**Consultation Response from Mike Hibbert,
KC Waste Strategy(Refuse & Recycling)**

2024/92312 adj, 99, Knowl Road, Mirfield, WF14 9RQ

Discharge of conditions 3 (materials), 6 (drainage strategy), 7 (electric vehicle charging points), 11 (landscaping), and 12 (waste storage and collection) of previous permission 2023/91465 for erection of two detached bungalows with associated access and landscaping

The applicant has submitted BLOCK PLAN Dwg No: (20) 002 dated 23/02/21 that shows the location of bin storage at each property on block paving car parking areas. These are screened from the Streetscene, are sufficient to accommodate three 240ltrs wheeliebins and are therefore acceptable.

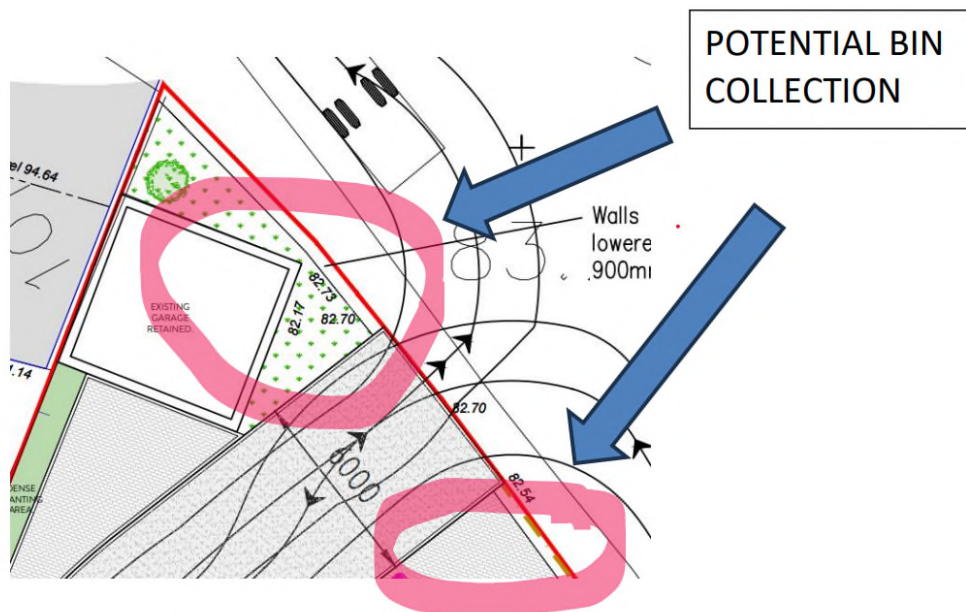
- The Authority will not take an RCV into private drives or roads that are not built to adoptable standards. Where roads are shown on the Plan, confirmation is sought these are adopted/ constructed to adoptable standard.

- Despite the bin drag out distance for Plot 2 being in excess of the 25m specified in guidance BS5906:2005 the provision of a Bin Collection Point for both plots next to the entrance onto Knowl Road, either on the area of block paving or adjacent to the retained garage, would enable more efficient collection than an RCV having to enter and turn around within the site,

The WCA will not accept discharge of the condition until the above points have been clarified.
